# Green Smart Shirts Ltd.

Tapirbari, Sreepur Gazipur- 1740 |  
(24.237098N, 90.433191E)  
30<sup>th</sup> April 2018

# Observation

# Missing bolt and corrosion on steel member

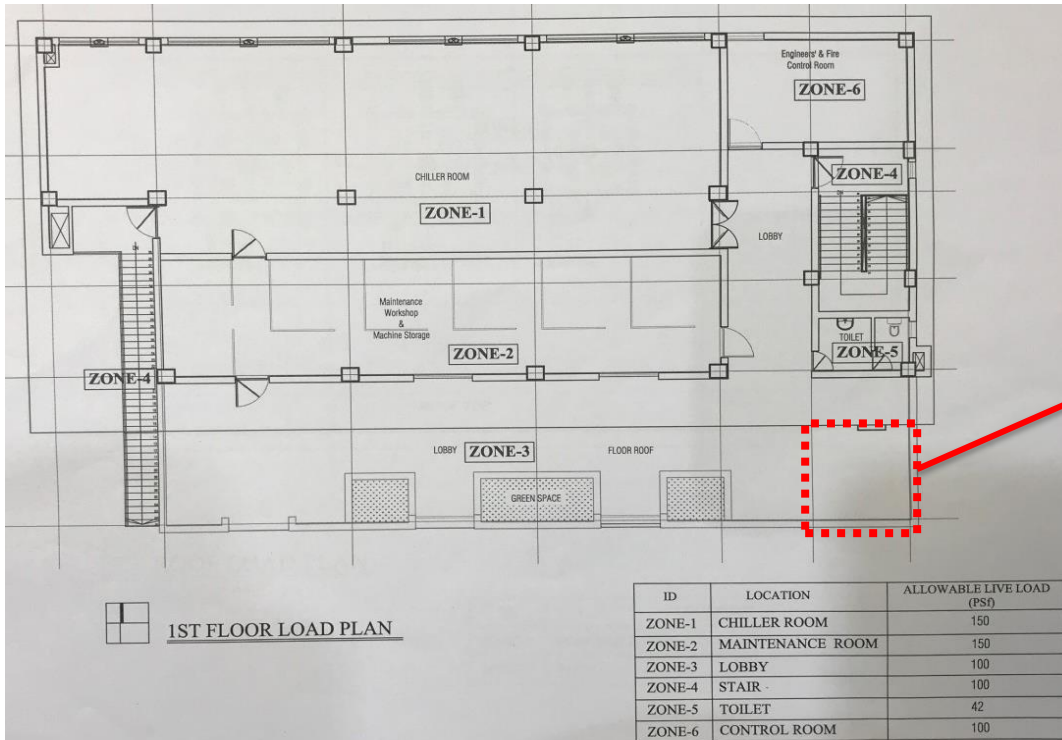
Missing Bolt at several locations

Corrosion was observed on steel columns. Factory is required to identify the locations and take proper remedial measures.

# Water ponding on lobby

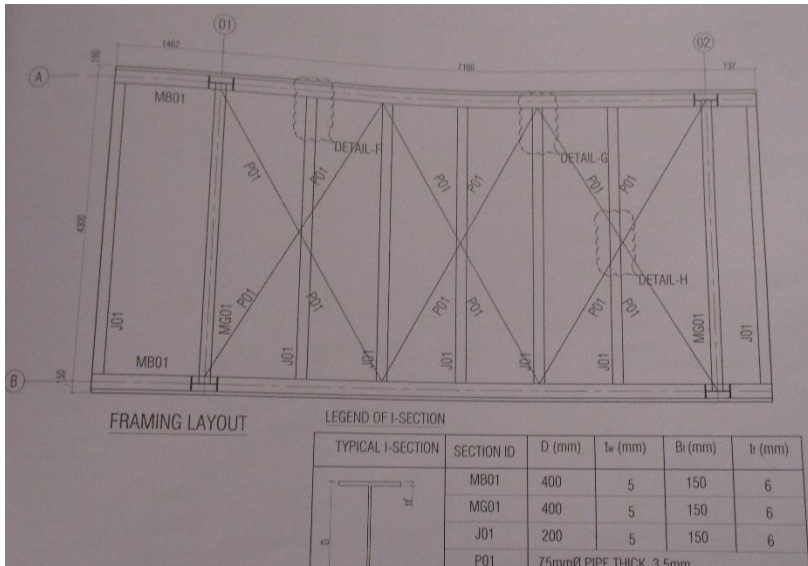
During inspection, water ponding was observed on lobby area. Factory is required to improve the drainage system for prevention of water ponding.

Frame bracing layout of connecting bridge

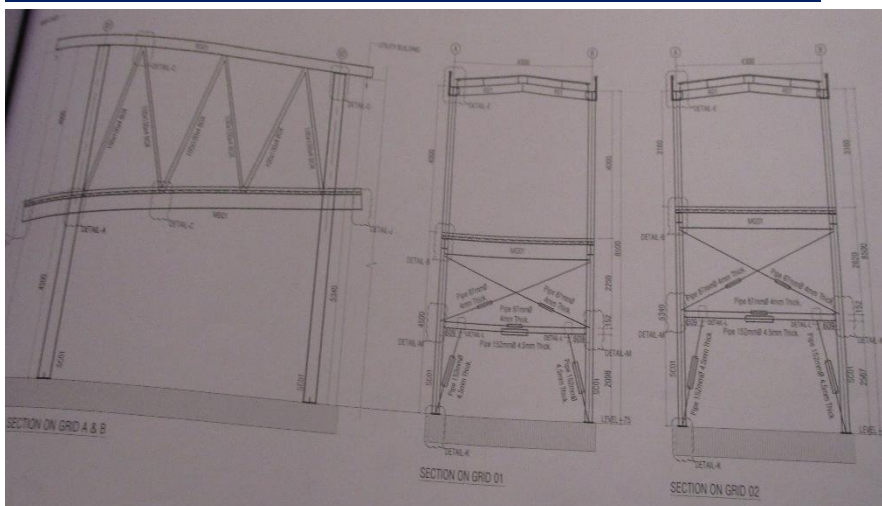
Frame not installed as per drawing

Provided bracing is blocking exit point. Building engineer is required to review design and replace bracing system.
